HINWEIS zum Anschluss der GU-Anbausets A-Öffner und A-Öffner servo

Temporäre Änderung der Aderbelegung beim A-Öffner-Kabel

NOTE concerning the connection of GU A-opener kit and A-opener servo kit

Temporarily modified wire allocation of A-opener cable

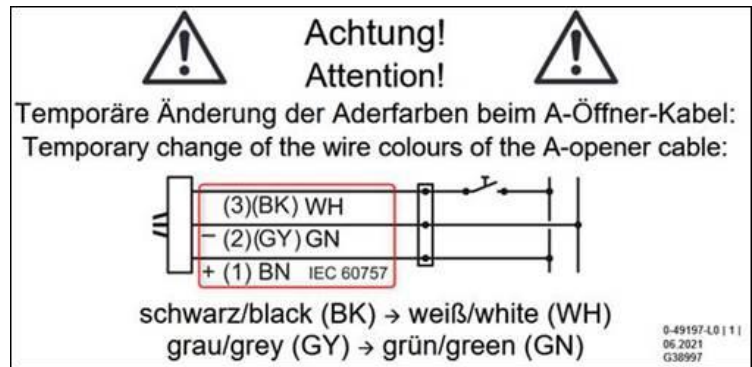
Aufgrund der Materialverknappung am Weltmarkt muss übergangsweise auf ein Anschlusskabel mit geänderter Adernfarbe ausgewichen werden. Nachstehende Übersicht bietet eine Übersetzung zum Anschluss.

Funktion	A-Öffnerkabel Übergangslösung	A-Öffnerkabel GU Standard	SECUREconnect 50 / 200
GND	GN	GY	GS
12 V AC / 12-24 V DC	BN	BN	VS
Steuerimpuls	WH	BK	90

Bisheriges A-Öffner Anschlusskabel (GU Standard)

Temporäres A-Öffner Anschlusskabel (Übergangslösung)

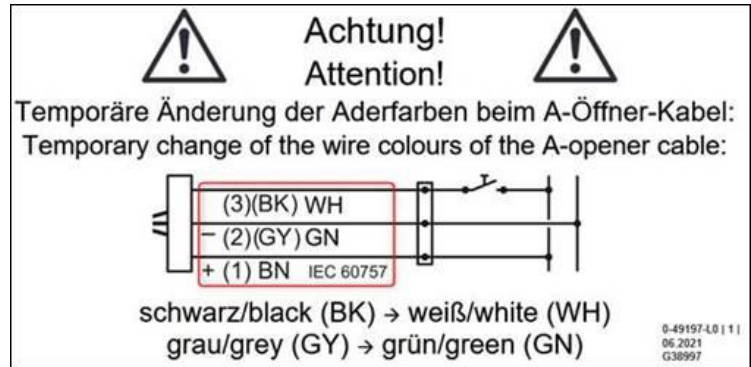
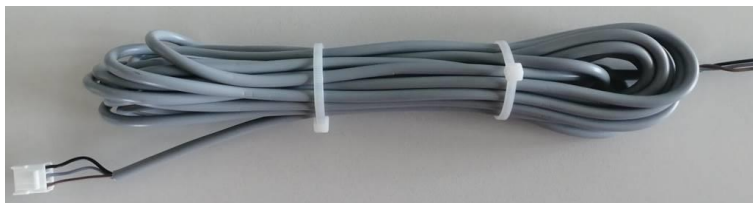
Due to material shortage, we have to switch temporarily to connection cables with another wire colour. Please see the following overview for further information.

Function	A-opener cable, interim solution	A-opener cable, GU standard	SECUREconnect 50 / 200
GND	GN	GY	GS
12 V AC / 12-24 V DC	BN	BN	VS
Control pulse	WH	BK	90

Previous A-opener connecting cable (GU standard)

Temporary A-opener connecting cable (interim solution)
